**CITY PLAN COMMISSION****THURSDAY, MAY 2, 2024****FILE NUMBER:** S234-097**SENIOR PLANNER:** Sharmila Shrestha**LOCATION:** Bexar Street, at the terminus of Pilgrim Drive**DATE FILED:** April 5, 2024**ZONING:** PD 595 MF-1(A)**PD LINK:** [Microsoft Word - ARTICLE 595 \(dallascityhall.com\)](#)**CITY COUNCIL DISTRICT:** 7**SIZE OF REQUEST:** 44.872-acres**APPLICANT/OWNER:** The Housing Authority of the City of Dallas

**REQUEST:** An application to create one 10.305-acre lot and one 34.567-acre lot from a 44.872-acre tract of land in City Block 7066 on property located on Bexar Street, at the terminus of Pilgrim Drive.

## PRELIMINARY PLAT

DALLAS HOUSING  
AUTHORITY ADDITION  
LOTS 1 AND 2, BLOCK A/7066  
1,954,644 Square Feet/44.872 Acres  
situated in the  
Solomon Silkwood Survey, Abstract No. 1345  
City of Dallas, Dallas County, Texas  
City Plan File Number: S 234-097

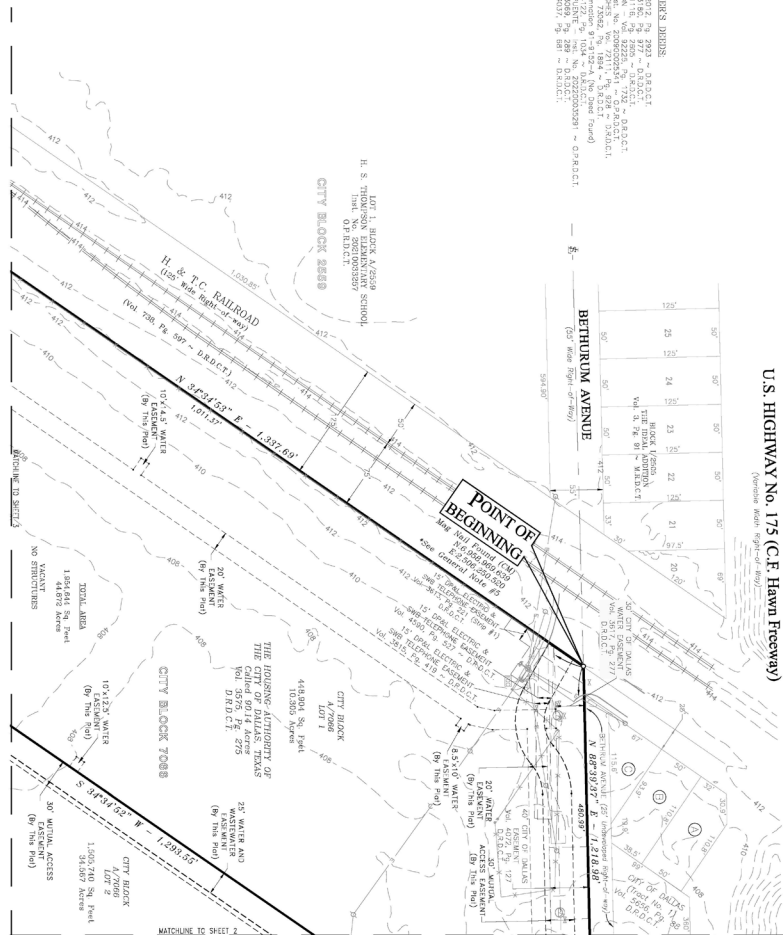
12. Submit a full set of Civil Engineering Plans (drainage, paving, street signage/markings/lighting) prepared per City Standards by a licensed (TX) Professional Engineer to Engineering Division in Room 200, Oak Cliff Municipal Center (i.e. 311T/DP). Additions and alterations to the public infrastructure require approval and may require private development contracts with bonds. 51A-8.102 (c); 8.601(b)(4),(5),(6),(7),(8),(9)
13. Detention may be required if the capacity of available outfall is not adequate to carry the developed runoff. *Section 51A-8.611(c)*.
14. Place a note on the final plat stating "Lot-to-Lot drainage will not be allowed without proper City of Dallas Engineering Division approval" 51A 8.611(e)

15. On the final plat, dedicate 25 feet of right-of-way (via fee simple) from the established center line of Bexar Street. *Section 51A 8.602(c)*
16. On the final plat, dedicate 28 feet of right-of-way (via fee simple or street easement) from the established centerline of Bethrum Avenue. *Sections 51A-8.602(c), 51A-8.604(c) and 51A-8.611(c)*.
17. On the final plat, dedicate 7.5 feet of right-of-way (via fee simple or street easement) from the established centerline of Alley on south property. *Sections 51A-8.602(c), 51A-8.604(c) and 51A-8.611(c)*.
18. On the final plat, dedicate a 15-foot by 15-foot alley sight easement at the intersection of Bexar Street & the alley. *Section 51A-8.602(e)*
19. Provide a turn-around per the City of Dallas Standards at the end of Woodville Street, Jarvis Street and Pilgrim Street. *Section 51A-8.506(b)*

20. Existing drainage conveyance within the property is required to be sized in compliance with Section 51A-8.611(a)(1) of the City of Dallas Code.

21. Prior to final plat, submit a completed final plat checklist and all supporting documents.
22. On the final plat, show how all adjoining right-of-way was created. Section 51A-8.403(a)(1)(A)(xxii).
23. On the final plat, show distances/width across all adjoining right-of-way.
24. On the final plat, show all additions or tracts of land within 150 feet of the property with recording information.

25. Additional design information is required for assessment. Site plan must be submitted showing proposed development, building finished floor elevation, development, existing mains – including downstream manhole, and proposed water and wastewater service locations. Submit water/wastewater engineering plans to 320 E. Jefferson Blvd., Room 200, Attention: Water and Wastewater Engineering.
26. Water and wastewater main improvements are required by Private Development Contract. Submit water/wastewater Engineering Plans to 320 E. Jefferson Blvd., Room 200, Attention: Water and Wastewater Engineering.
27. Engineer must furnish plans for water and sanitary sewer. Developer must furnish a contract for water and sanitary sewer. Sections 49-60(g)(1) and (2) and 49-62(b), (c), and (f).

28. On the final plat, add “Railroad Avenue” to unnamed ROW.
29. On the final plat, change “US Highway No. 175 (C.F. Hawn Freeway)” to “C. F. Hawn Freeway/ U.S. Highway No. 175 (FKA Lowery Avenue)”.
30. On the final plat, change “Bethrum Avenue” to “Bethurum Avenue”.
31. On the final plat, identify the property as Lots 1 and 2 in City Block A/7066.
